## Observations on Dart+ West Draft Railway Order

October 2022 – John Devitt

Figure 1 – Estimated time by road from Blanchardstown Fire Station to Carpenterstown (off peak) via Coolmine Level Crossing

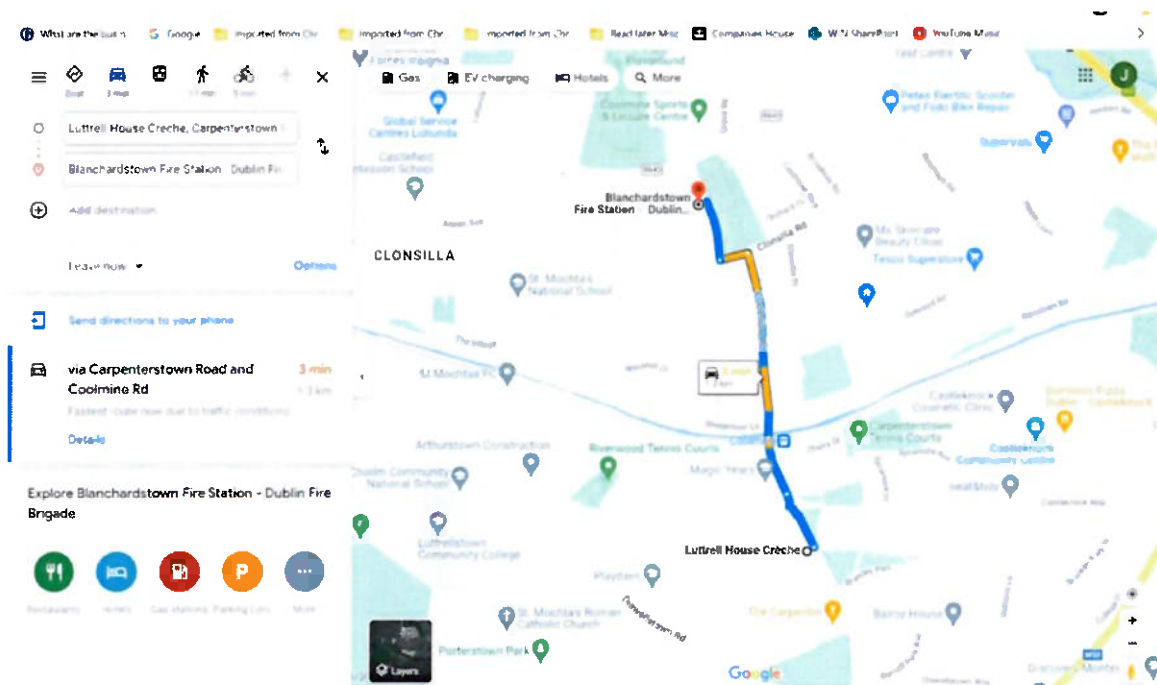
As can be seen from the screenshot at Figure 1 below, communities in Laurel Lodge and Carpenterstown that rely on emergency fire and ambulance services provided by Dublin Fire Brigade on Snugborough Road can be served within three minutes of a call being made to dispatch.

Figure 3 – Estimated time by road from Blanchardstown Fire Station to Carpenterstown

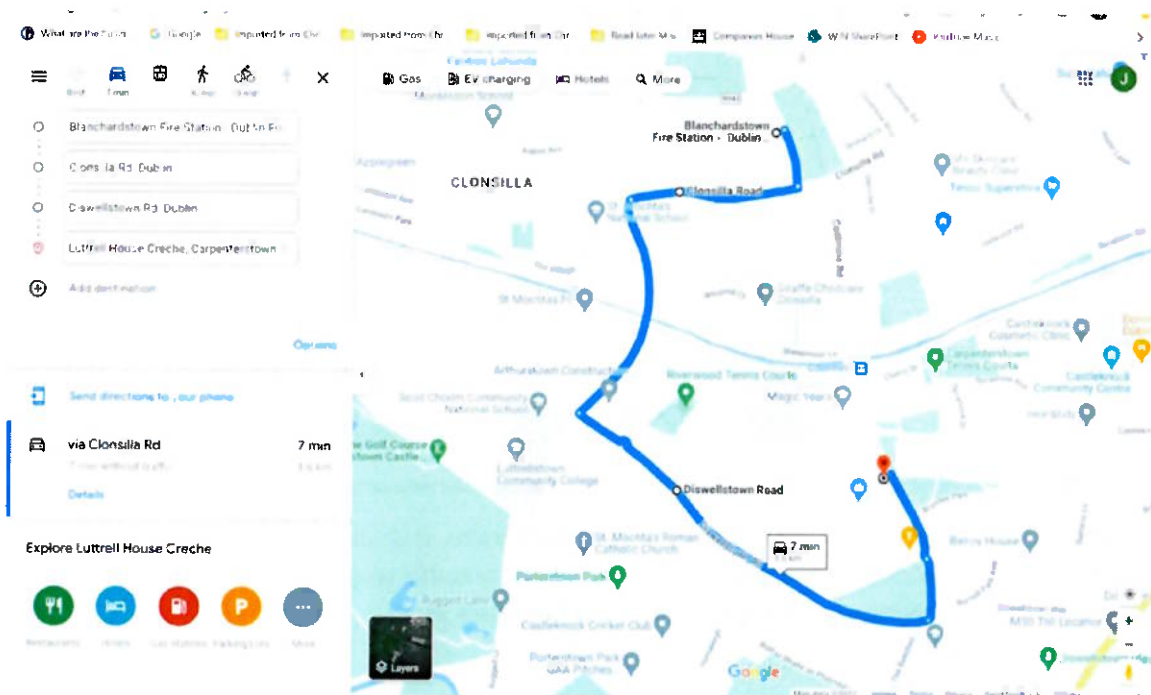
However, the permanent closure of the level crossing at Coolmine to road traffic will more than double the time it takes to access Carpenterstown at off peak times from three to seven minutes (see figure 3)

The potential impact of increased response times to medical and other emergencies is both significant and avoidable if appropriate measures are adopted to improve waiting times and safety measures at Coolmine Level Crossing (see Recommendations). It is equally pointless, given that there are no proposals to run Dart and Commuter Rail services after midnight. The closure of the level crossing for 24 hours a day to road traffic will needlessly delay local emergency services at
